## Product Change Notice (PCN)

PCN Number: **PCN-0450983R-01**

Product(s) Affected: *SJ1-353XNS Series (SJ1-3533NS & SJ1-3534NS)*

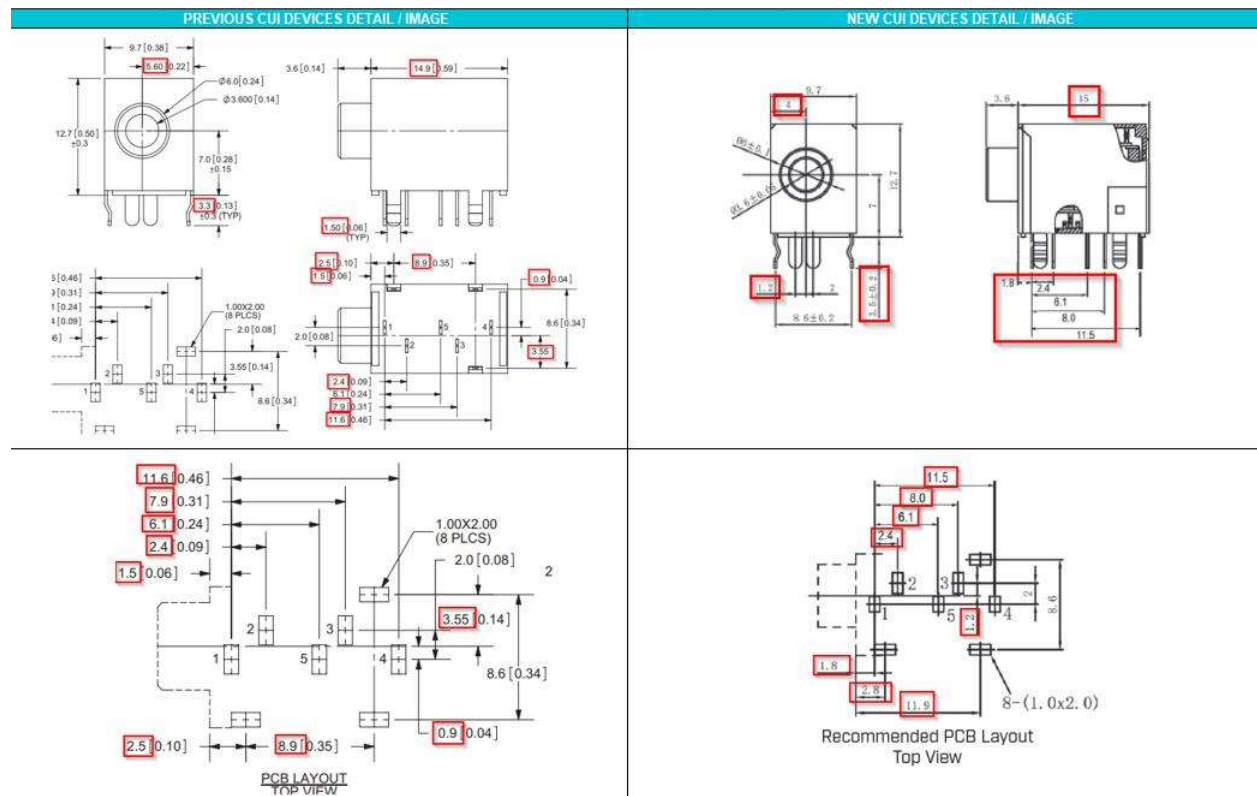
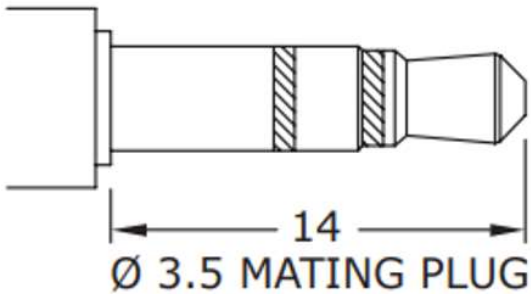
Description of Change: *Minor Housing and footprint differences. Material Change on the housing and terminals. See image Below*

PREVIOUS CUI DEVICES DETAIL / IMAGE			NEW CUI DEVICES DETAIL / IMAGE		
	MATERIAL	PLATING	DESCRIPTION	MATERIAL	PLATING/COLOR
terminal 1	brass	tin	terminal 1	brass	silver
terminal 2	brass	tin	terminal 2	phosphor bronze	silver
terminal 3	brass	tin	terminal 3	phosphor bronze	silver
terminal 4	brass	tin	terminal 4	brass	silver
terminal 5	brass	tin	terminal 5	brass	silver
spring	stainless steel		spring	stainless steel	nickel
bushing	brass	nickel	bushing	brass H59	nickel
shield	cold rolled steel	nickel	shield	SPCC t=0.30	nickel
plastic	PBT		housing	PBT (UL94V-0)	black
